Access Compliance Report

Public Rights-of-Way

(Curb Ramps)

Intersection ID: 31510	Main Street: GRIER_SPRINGS_LN	Cross Street: CONNELL_GREEN_DR	Location: NW
ADA ID: 9CA582B81C2C	Ramp Type: BlendTrans1	Initial Pass/Fail: Fail	Overall Compliance: No
			Severity Score: 21.25

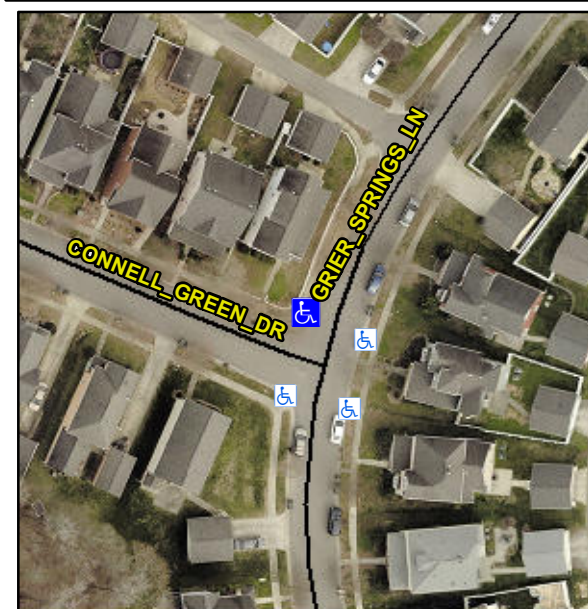
R304.5.1, R304.5.3

Compliance	Description	Data	Compliance	Description	Data
N/A	Ramp Length (in)	62.5	Yes	BlendTrans Slope (%)	4.7
No	Ramp Width (in)	40.0	No	BlendTrans XSlope (%)	6.2
N/A	Flare Type LT	N/A	N/A	Flare Type RT	N/A
N/A	Flare Slope LT (%)	N/A	N/A	Flare Slope RT (%)	N/A
N/A	Flare Traversable LT?	N/A	N/A	Flare Traversable RT?	N/A
N/A	Landing Length (in)	N/A	N/A	DWS Provided?	N/A
N/A	Landing Width (in)	N/A	N/A	DWS Contrast?	N/A
N/A	Landing Slope (%)	N/A	N/A	DWS Length (in)	N/A
N/A	Landing X Slope (%)	N/A	N/A	DWS Full Width?	N/A
N/A	Landing Curb? (Y/N)	N/A	N/A	DWS Offset (in)	N/A
N/A	Shared Landing?	N/A			
N/A	Gutter Ponding?	N/A	N/A	Gutter Slope (%)	N/A
N/A	Gutter Lip Ht (in)	N/A	N/A	Gutter X Slope (%)	N/A
N/A	Painted X Walk1?	No	N/A	Painted X Walk2?	No
	X Walk 1 Direction	To SW		X Walk 2 Direction	To SE
	X Walk 1 Width (in)	N/A		X Walk 2 Width (in)	N/A
	X Walk 1 Slope (%)	2.2		X Walk 2 Slope (%)	7.9
	X Walk 1 X Slope (%)	8.4		X Walk 2 X Slope (%)	2.4

Remove & Replace Curb Ramp With Two New Directional Ramps or Equivalent.
